Planning and Zoning Board Agenda January 12, 2021

SUBJECT:	A request for consideration of a Final Plat of Dogwood Acres – Lot 12A, being a replat of Lot 12A of Dogwood Acres – First Addition Replat as recorded in Plat Book 22, Page 73 of the Public Records of Alachua County, together with a 30 foot strip adjacent to the west line of Lot 12A (minor subdivision review)
APPLICANT/AGENT:	Stacy Hall, P.S.M, George F. Young, Inc.
PROPERTY OWNER:	John A. Sapp and Antoinette Pratto-Sapp
PARCEL ID NUMBER:	03013-020-012
FLUM DESIGNATION:	Moderate Density Residential
ZONING:	Agricultural (A)
OVERLAY:	N/A
ACREAGE:	±3.93
PROJECT PLANNER:	Justin Tabor, AICP
RECOMMENDATION:	Staff recommends that the Planning & Zoning Board transmit the final plat of Dogwood Acres – Lot 12A to the City Commission with a recommendation to approve.
RECOMMENDED MOTION:	<i>Based upon the competent substantial evidence presented at this hearing, the presentation before this Board, and Staff's recommendation, this Board finds the application to be consistent with the City of Alachua Comprehensive Plan and in compliance with the Land Development Regulations and transmits the final plat of Dogwood Acres – Lot 12A to the

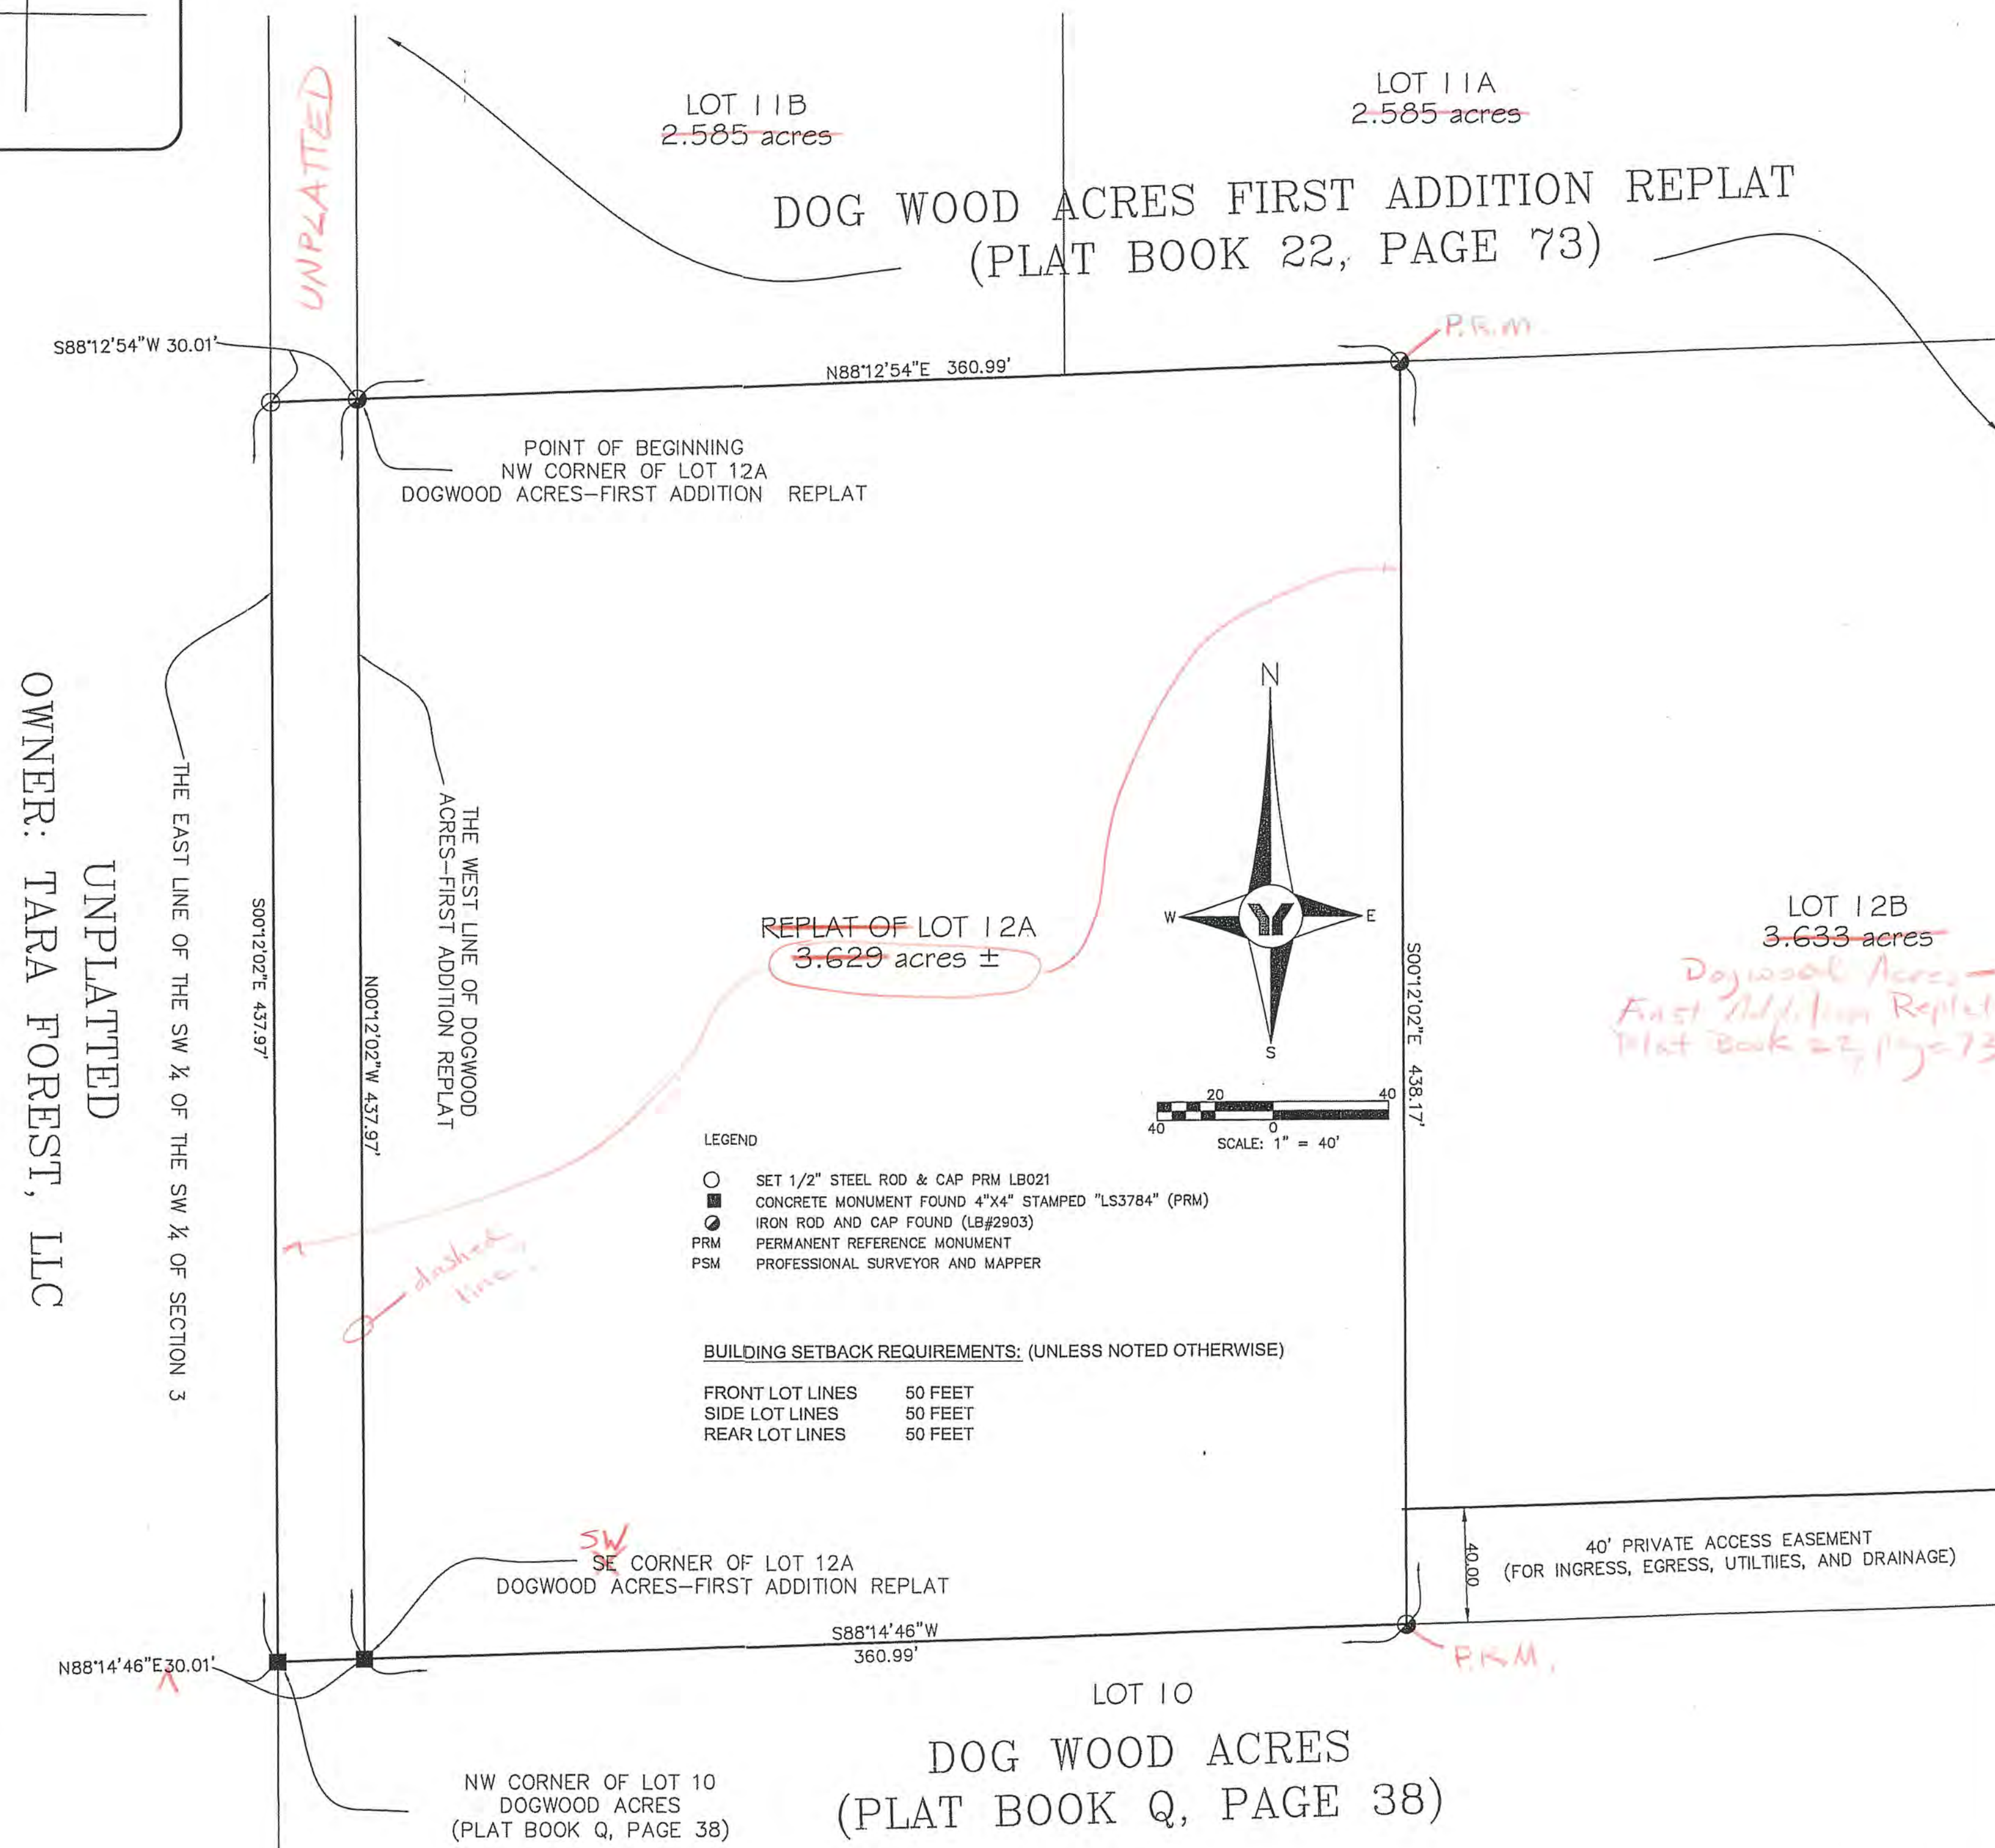
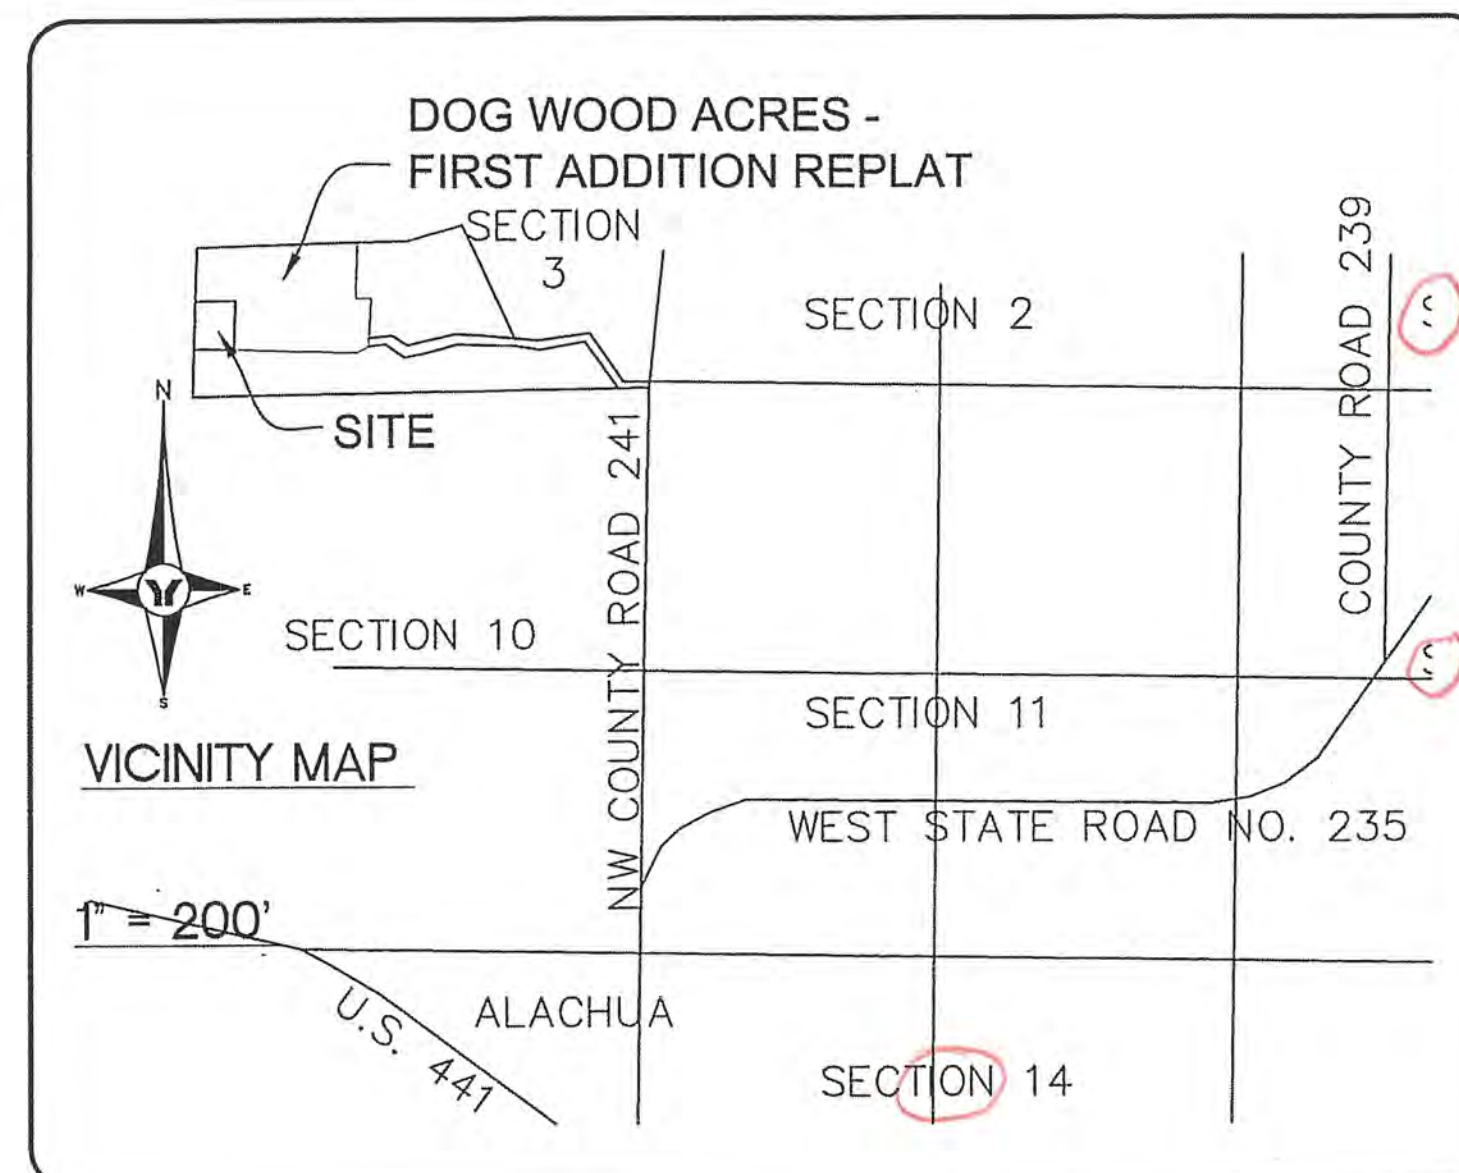
- a. 177.091(11): Each plat shall show a description of the lands subdivided, and the description shall be the same in the title certification. The legal description attached as Exhibit "A" to the title certification does not include the "together with" and header language for the 30' strip of land.

- a. There is a typographical error in the first sentence of the owners certification (present-s-).
- b. Add lines for the date to be inserted for signature block and date for John Sapp and Anotinette Pratto-Sapp in the owners certification.
- c. Add signature lines for two witnesses for both John Sapp and Antoinette Pratto-Sapp in the owners certification.
- d. Delete the period after Antoinette Pratto-Sepp in the acknowledgment of the owners certification.
- e. The acknowledgment of the owners certification should use plural nouns and pronouns ('drivers licenses' and 'they').
- f. The year in the notary block of the acknowledgement of owners certification should be 2021.
- g. The year in the certificate of approval by the Clerk of the Court should be 2021.

- (11) The Legal Description contains dimensions that are "more or less"; it is my opinion that the Legal Description needs to be revised with dimensions that are stated to the nearest 1/100 of a foot, Or the dimensions shown on the plat need to be revised to "+/-".

- (16) The easements identified in the Title Opinion must be shown on the Plat.
If the subject property remains subject to recorded Covenants and Restrictions identified, I feel a note to this effect should be added to the Plat.
